7.4 NoR 4: SH1 Improvements - Urban Design Matters

Table 7: Urban Design Evaluation for NoR 4 – SH 1 Improvements

7.4.1 NoR 4: SH1 Improvements Outcomes and Opportunities Maps

OUTCOMES AND OPPORTUNITIES PLAN - SHEET 3 OF 4

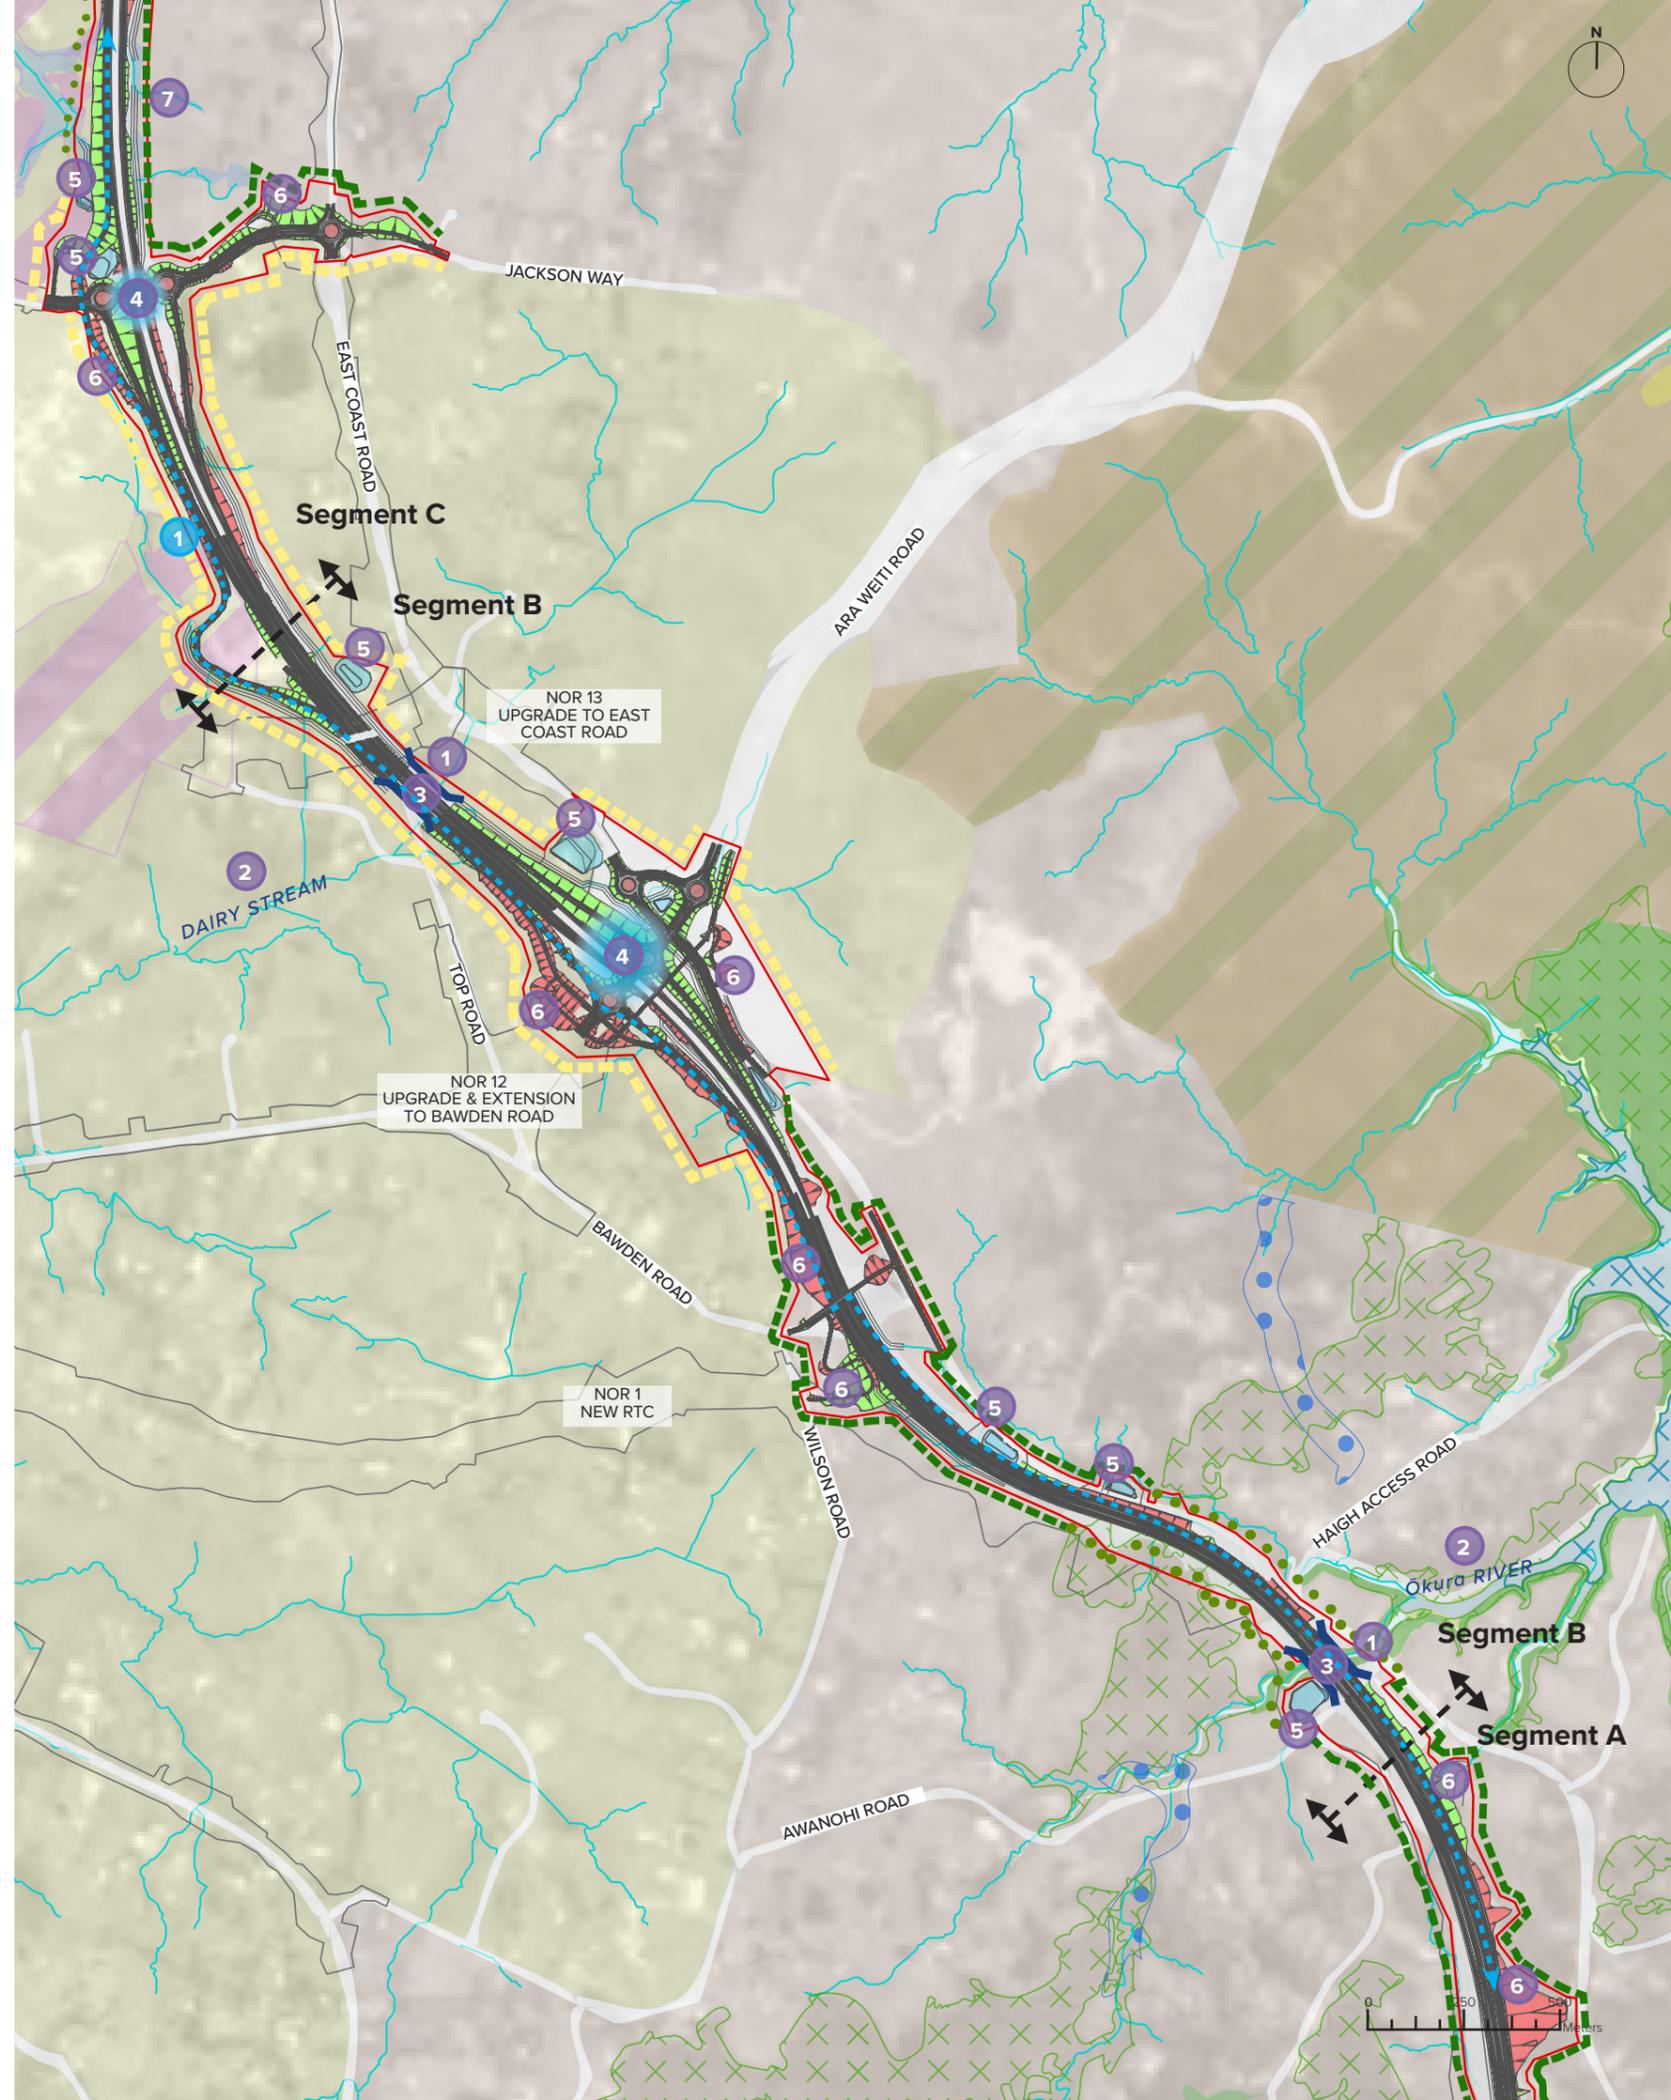
- 1 **Ecological connectivity** - Landscape outcomes should reinforce the wider vegetation patterns of the local open spaces and support ecological connectivity and biodiversity where the corridor crosses Ōkura Creek and Huruhuru (Dairy Stream) and its tributaries.

- 2 **Identity drivers** - Key local community, landscape character and identity drivers should be identified, developed and integrated with the adjacent land use functions and future design response, including adjacent Ōkura Creek and Huruhuru (Dairy Stream).

- 3 **CPTED** - Future design should incorporate CPTED principles including clear sightlines, good levels of lighting and passive surveillance, particularly at intersections and future cross-corridor connections. This should be a consideration of the active mode facilities which may have limited passive surveillance along the corridor from adjacent land use.

- 4 **Active mode legibility and priority** - Legibility, connectivity demands, safety and modal priority for active modes should be addressed at intersections.

- 5 **Stormwater Wetlands** - Consider integration outcomes for wetland/s such as setbacks, arrangement and scale of planting to support an appropriate interface to the road corridor, adjacent land use and development.

- 6 **Earthworks** - Design earthworks at corridor boundaries to establish an appropriate interface with State Highway 1. Use retaining structures in areas where space is insufficient to deploy earthworks batters or where earthworks negatively impacts the efficiency of adjacent landuses. Where mass planting is proposed on batters, use native ecologically appropriate species.

- 1 **Gateway into Dairy Flat** - The upgraded corridor will provide direct access into the Dairy Flat area, and the future design of the corridor, should consider the opportunity to provide a gateway into the area, assisting in way finding and defining the transition between land uses.

Establish an appropriate interface with the State Highway One corridor that manages the relationship between the corridor and adjacent land use and considers the amenity and safety of the active mode corridor.
	Establish an interface that responds to the adjacent rural zone, integrating the corridor into the adjacent land form and include appropriate planting and screening.
	Establish landscape outcomes that provides an appropriate interface to the blue and green network.
	Consideration of visual integration, interface and sense of place for the bridge structure.
	Intersection arrangement that addresses multi-modal priority, safety and legibility.
